**From:** Waters, David [David.Waters@pgnmail.com]  
**Sent:** Thursday, July 26, 2012 11:08 AM  
**To:** Habib, Donald  
**Cc:** Rose, Dana  
**Subject:** QAPD Draft Update  
**Attachments:** Part 11 QAPD DRAFT\_RL\_SO\_07232012.pdf

**NGGM-PM-0033**

**Title: New Nuclear Plant Development Quality Assurance Program**  
**Description Topical Report**

**Levy Nuclear Power Plants Units 1 and 2**  
Docket Nos. 52-029 and 52-030

Figure II.1-1

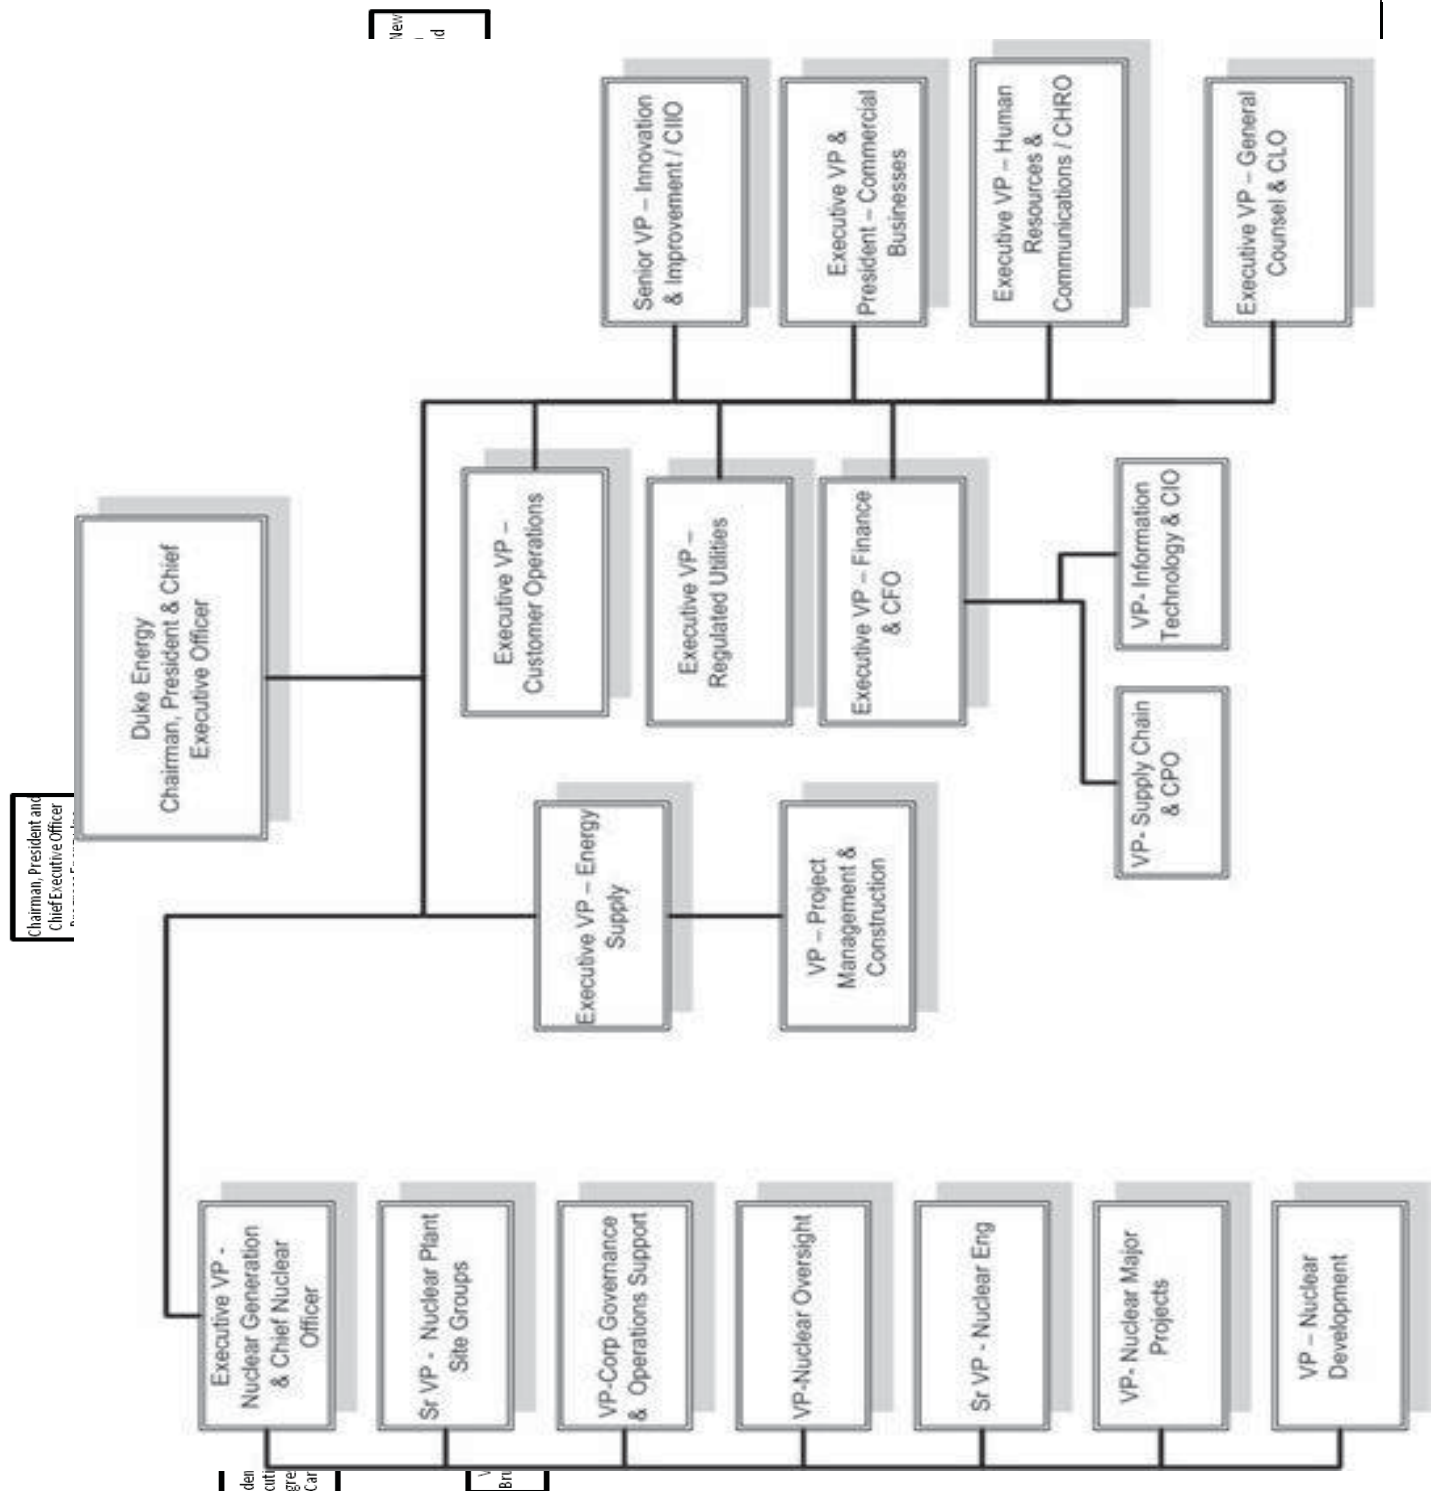
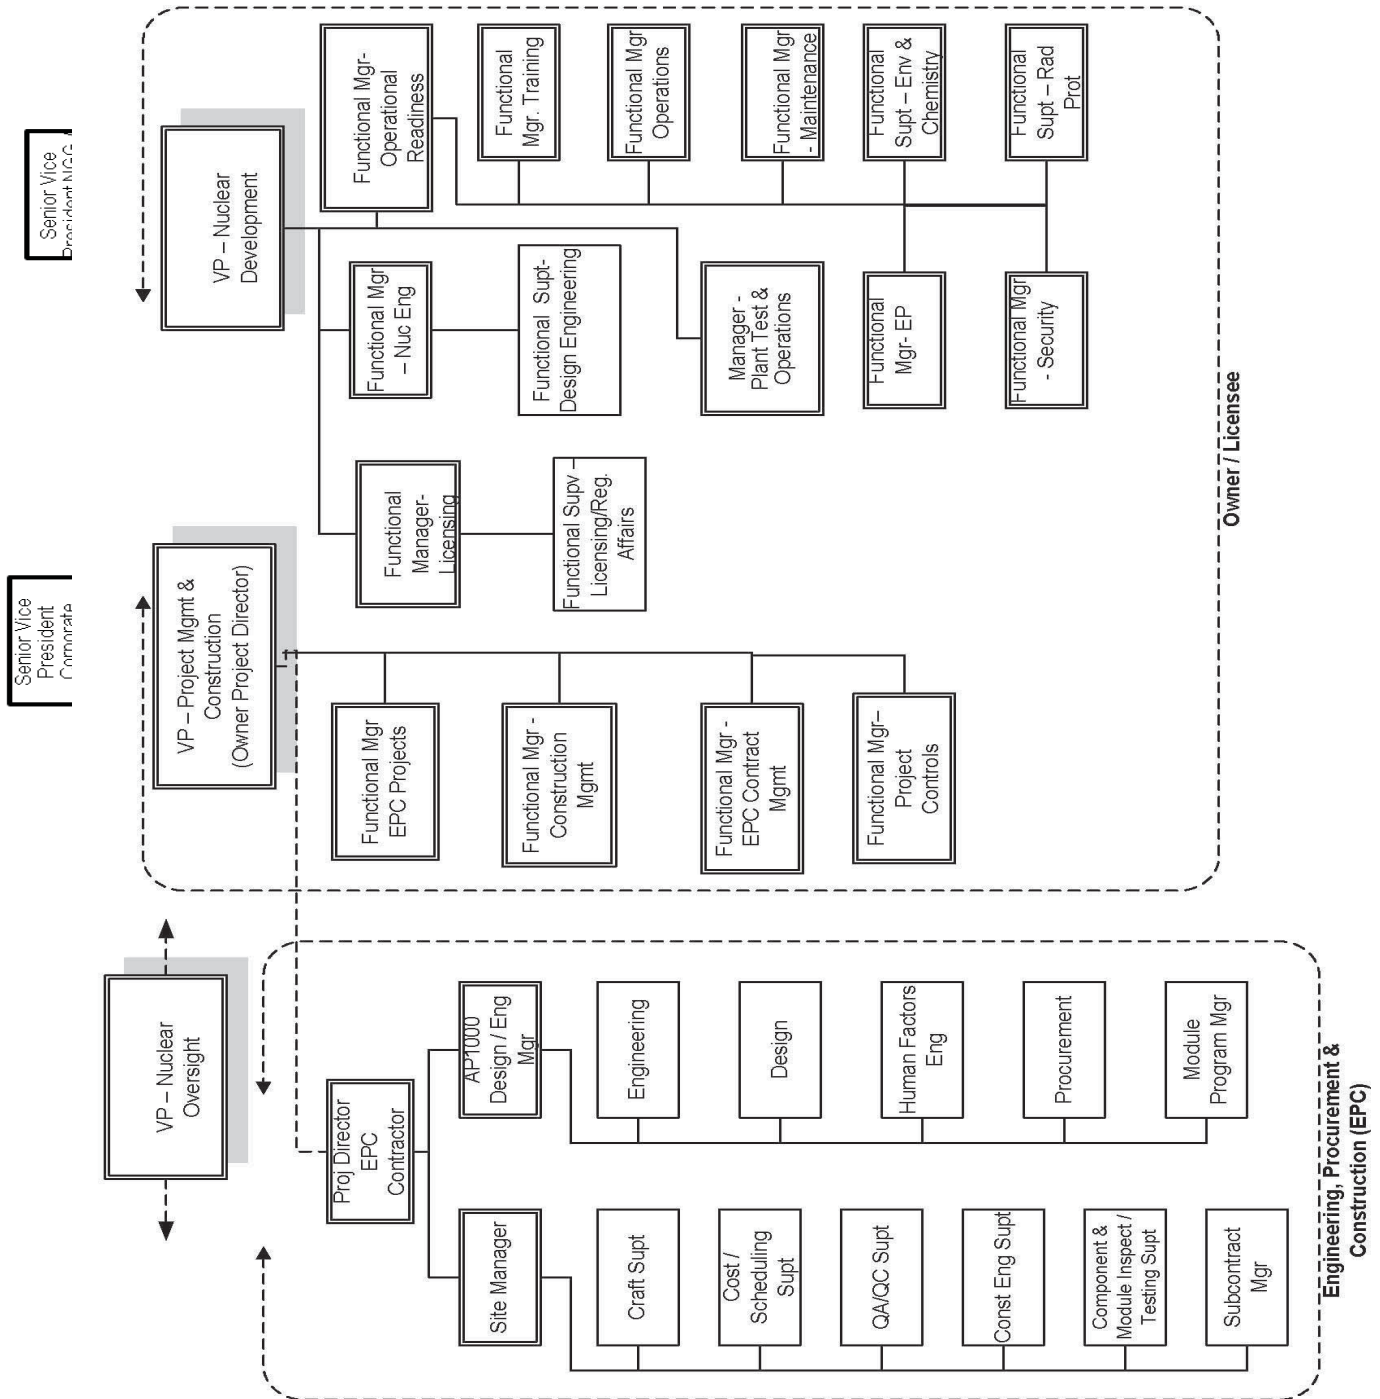
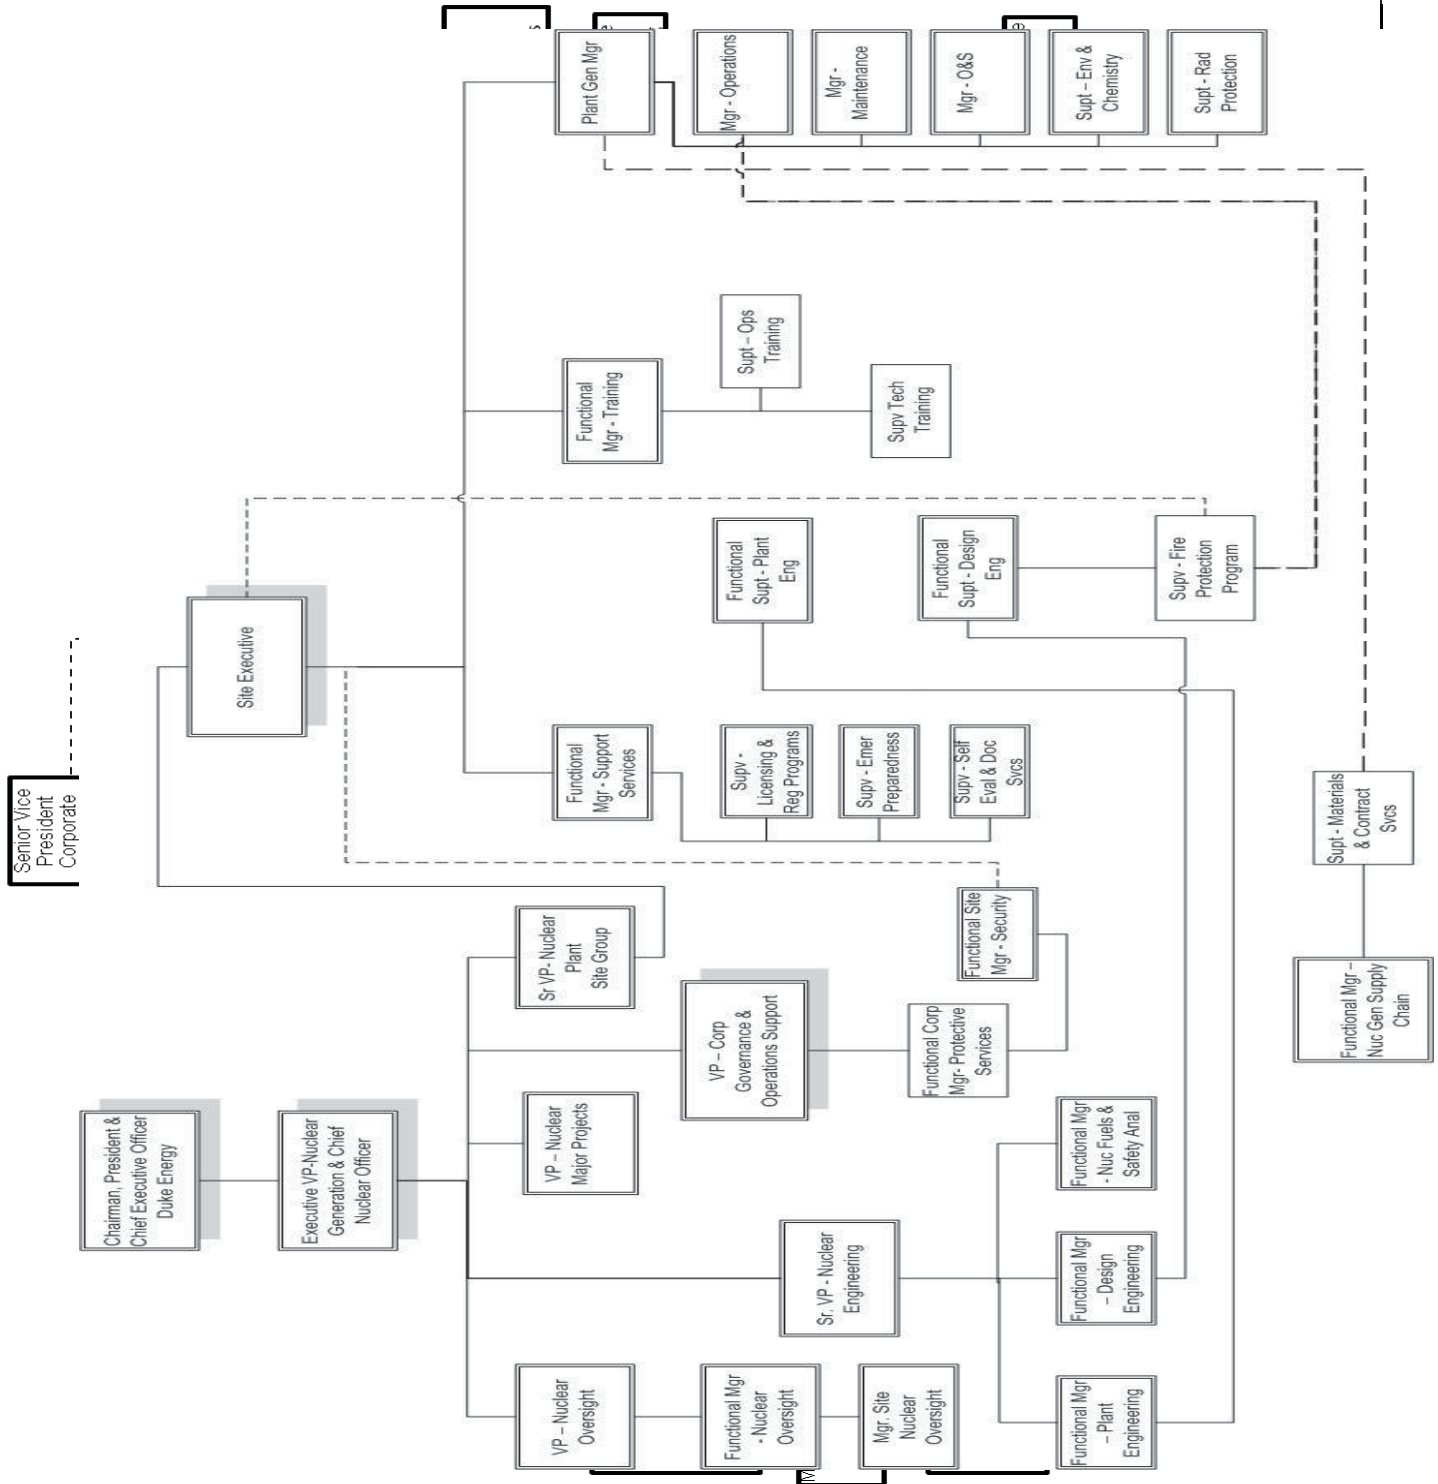
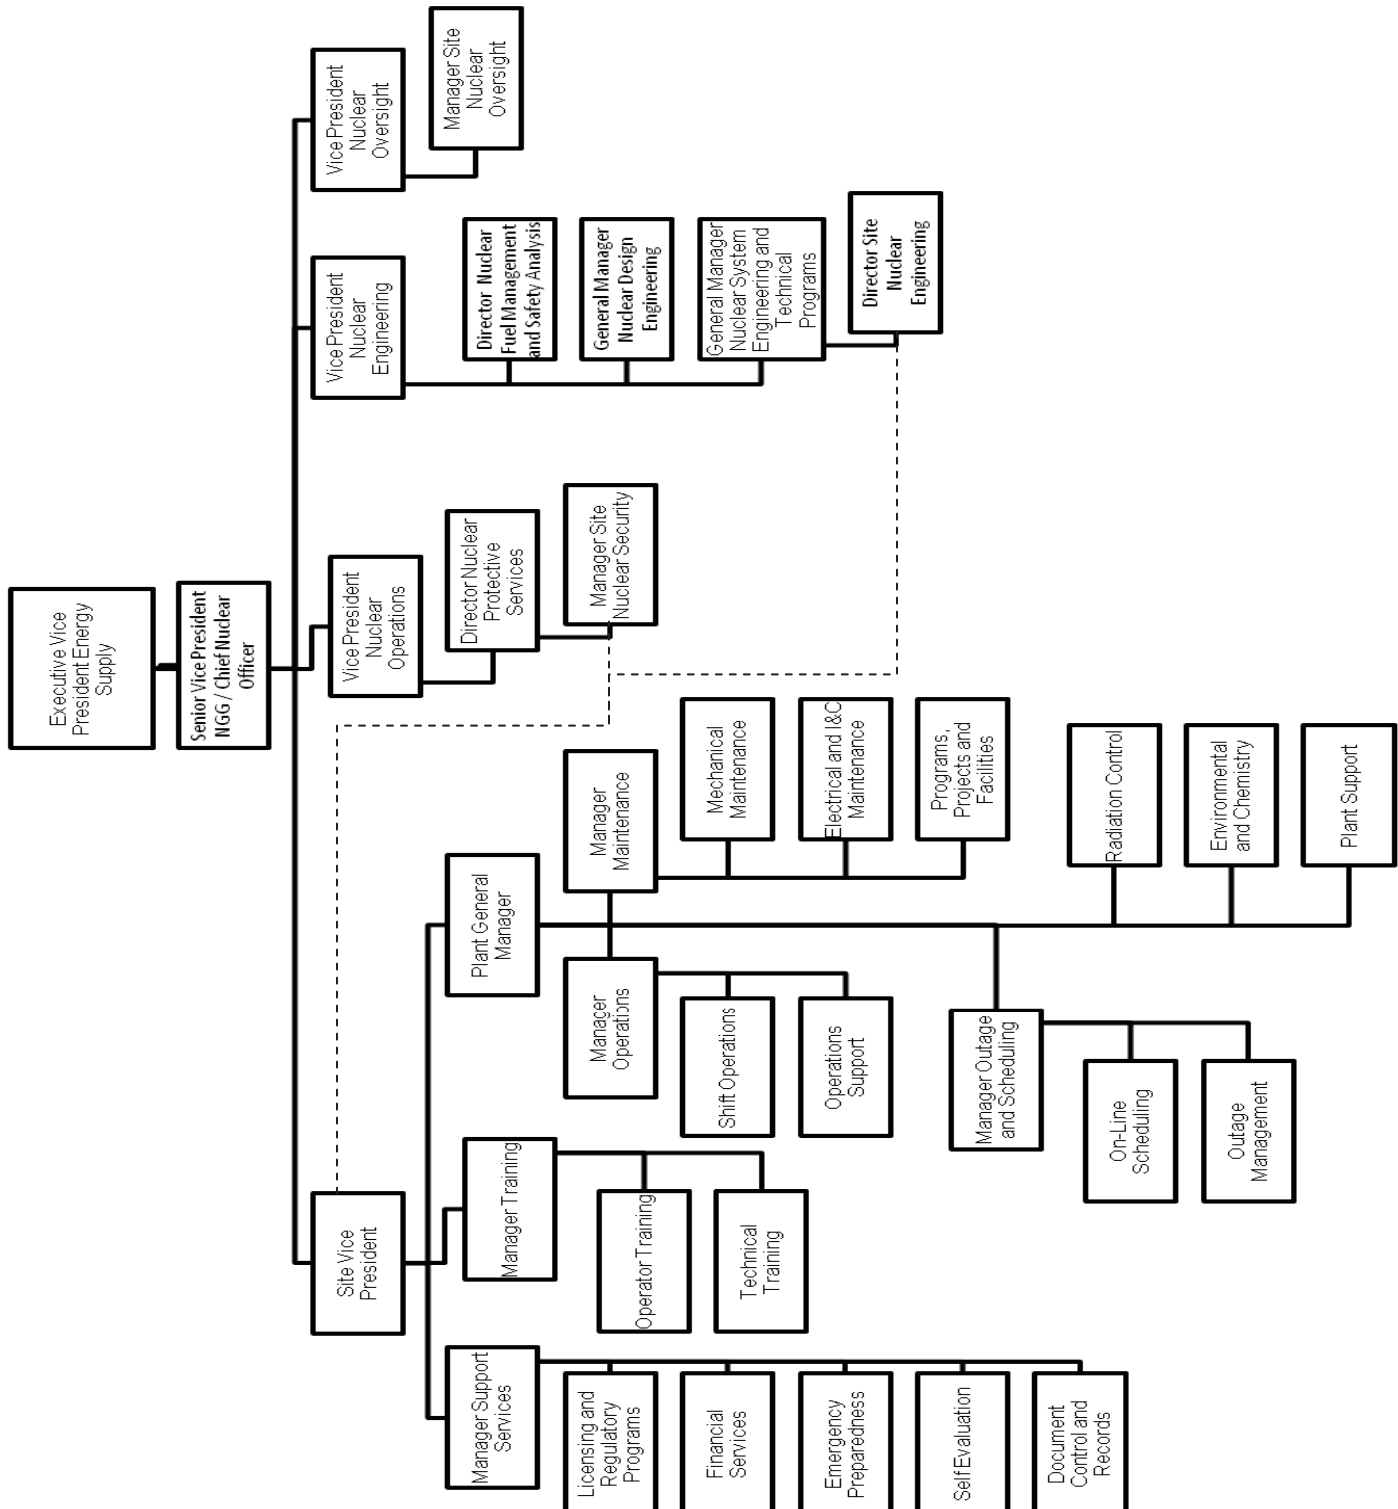
- Part II, Section 1.5 – 1.10 – Changed section numbering to reflect changes in section. No changes in section descriptions.
- Part II, Figures II.1-1, II.1-2, and II.1-3 – Revised figure to reflect new organizational structure and titles.
